FLYING HORSE NORTH FILING NO. 7
CONSTRUCTION DRAWINGS

FLYING HORSE NORTH FILING 7
PRI #2, LLC.
EL PASO COUNTY, CO

CONSTRUCTION DOCUMENTS
COVER

DP7 CONCRETE RUNDOWN TOEWALL

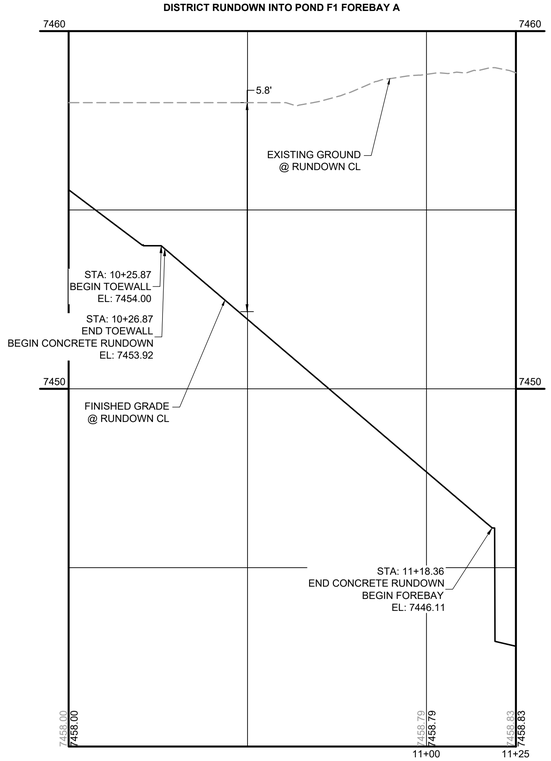
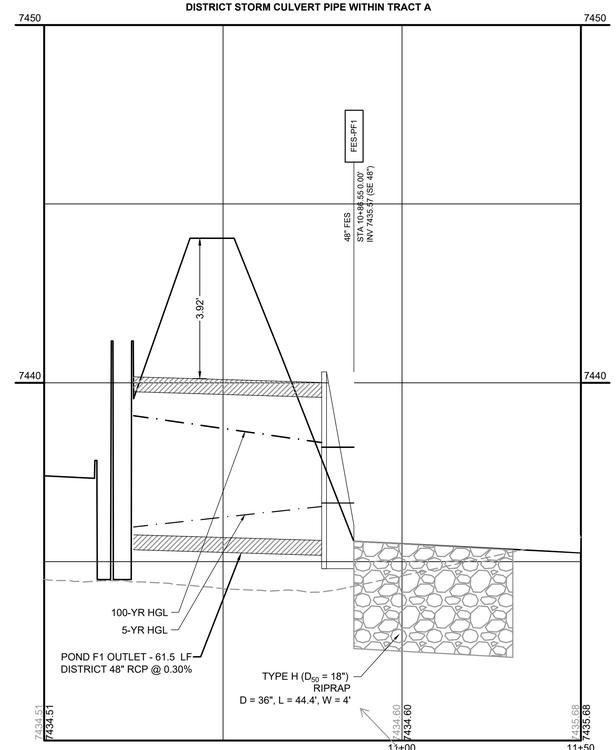
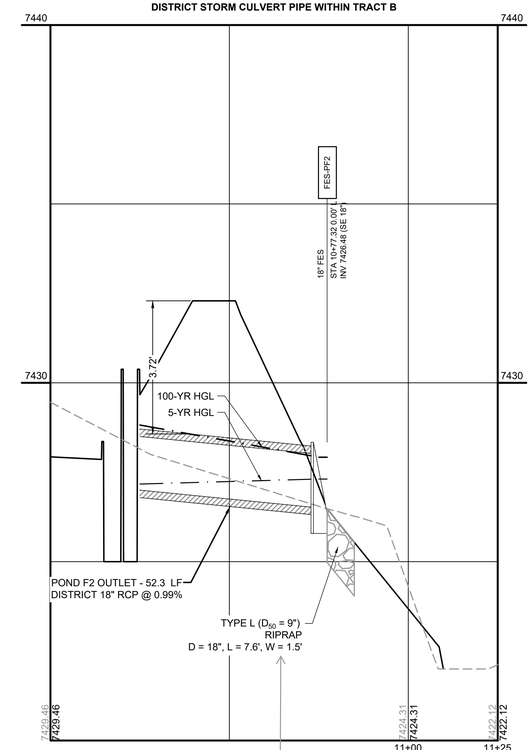
Provide bedding material/geotextile fabric between riprap and sub-base (per DCMv1 – Chap 10.10.5). Per recent discussions with a geotextile provider, a woven geotexile is more appropriate for this application as it has resistance (via tensile strength) to tearing when the riprap is placed. Nonwoven fabric will tear. Please contact a supplier to call out an appropriate model # for a woven geotextile on these plans.

HRG Response:
Riprap detail on sheet 2 for bedding specification.
